RE: Agreement No. 2048
Traffic Impact Study Services
Task 10A-The Centre at Hearthstone Manor

Johnson, Mirmiran and Thompson (JMT) has completed the review of the Final Traffic Impact Study (TIS) for The Centre at Hearthstone Manor development, prepared by C. David Jamison, PE (CDJ). This review was assigned Task Number 10A. CDJ prepared the report in a manner generally consistent with DeIDOT's *Standards and Regulations for Subdivision Streets and State Highway Access*.

THE CENTER AT HEARTHSTONE MANOR
TRAFFIC IMPACT STUDY
SUSSEX COUNTY, DELAWARE

FIGURE 1

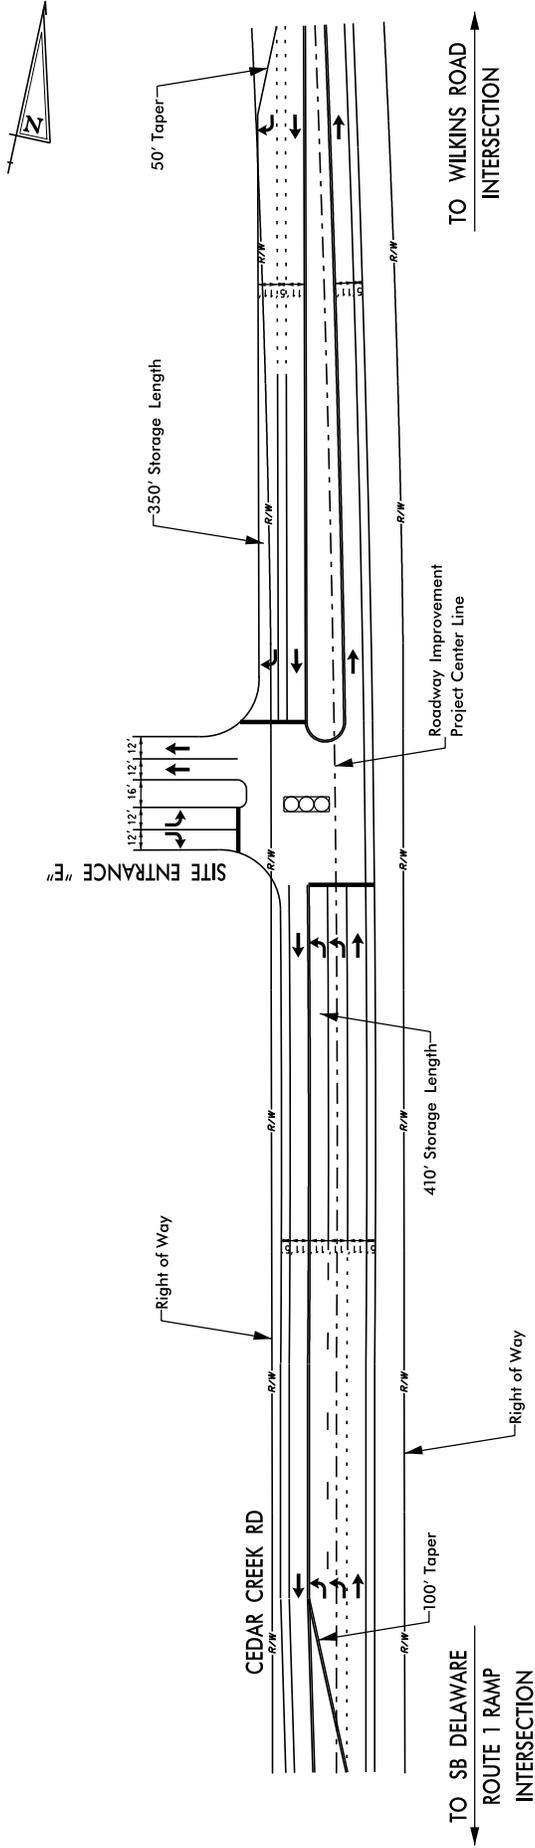
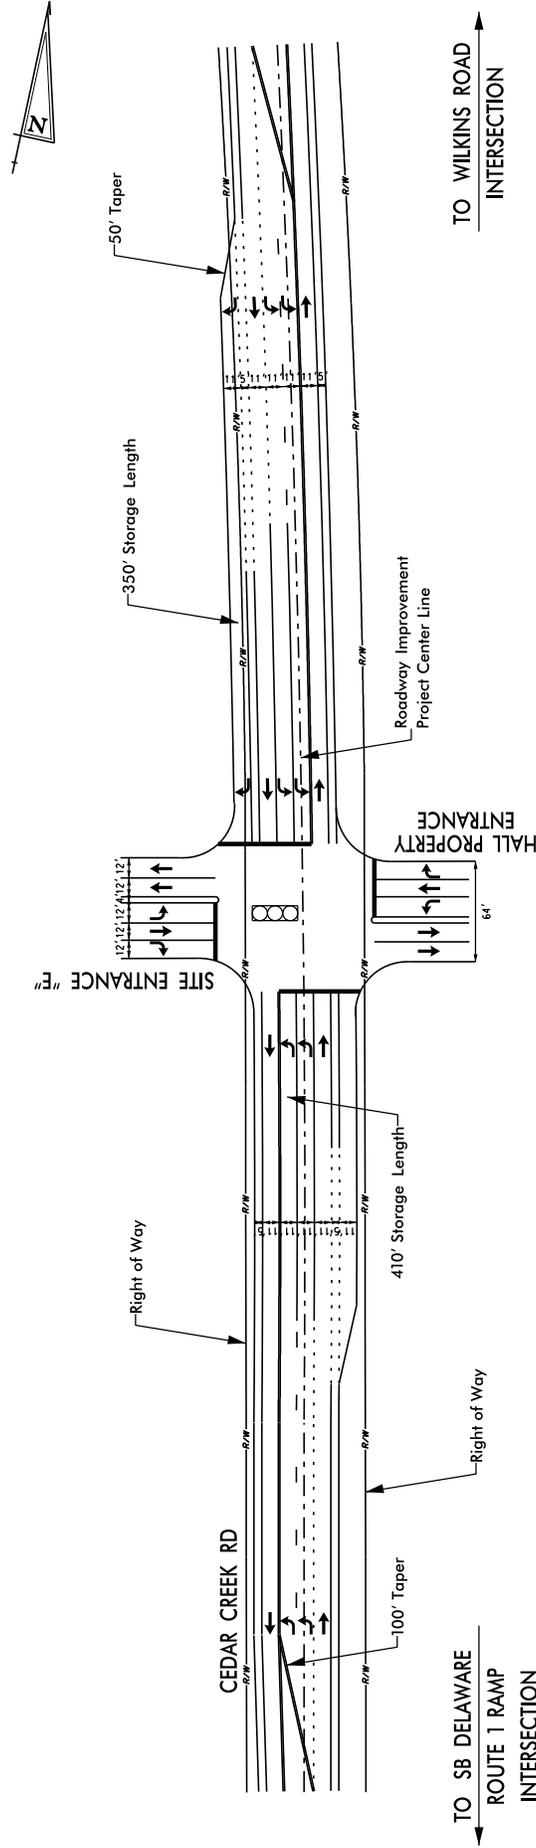
With the development of both The Centre at Hearthstone Manor and the Hall Property, the intersection of Cedar Creek Road with Site Entrance E and the Hall Property entrance would exhibit LOS deficiencies during all peak periods. To address these expected LOS deficiencies, a traffic signal should be installed when it is warranted per a signal justification study and the northbound and southbound Cedar Creek Road approaches should provide two left turn lanes, one through lane, and one right turn lane. Additionally, Site Entrance E and the proposed Hall Property entrance should provide one left turn lane, one through lane, and one right turn lane.

Enclosed Figure 2 depicts the conceptual layouts for the Site Entrance E/Cedar Creek Road intersection with and without the Hall Property entrance. As depicted on Figure 2, additional right of way (approximately 10 feet) may be needed from the westerly side of Cedar Creek Road when two left turn lanes are installed along either the northbound or southbound approaches. Furthermore, with the provision of two left turn lanes along either the northbound or southbound approaches, restriping and roadway realignment may be needed to tie into the Wilkins Road and southbound Delaware Route 1 Ramp intersections. Therefore, as part of Entrance Plan design, the developer should submit a plan depicting the limits of work and coordinate with DelDOT Subdivision Section to determine the exact intersection layout and resulting impacts along Cedar Creek Road.

6. In anticipation of the need for future widening of Cedar Creek Road to accommodate southbound left turn lanes at the intersection of Cedar Creek Road and Site Entrance E, the developer should dedicate to DeIDOT sufficient right of way (approximately 10 feet) along the Cedar Creek Road site frontage. The specific right of way dedication needed should be determined during the Entrance Plan review process. Further, the developer should submit a plan and coordinate with DeIDOT Subdivision Section to identify additional restriping and realignment modifications needed to accommodate the turn lanes.
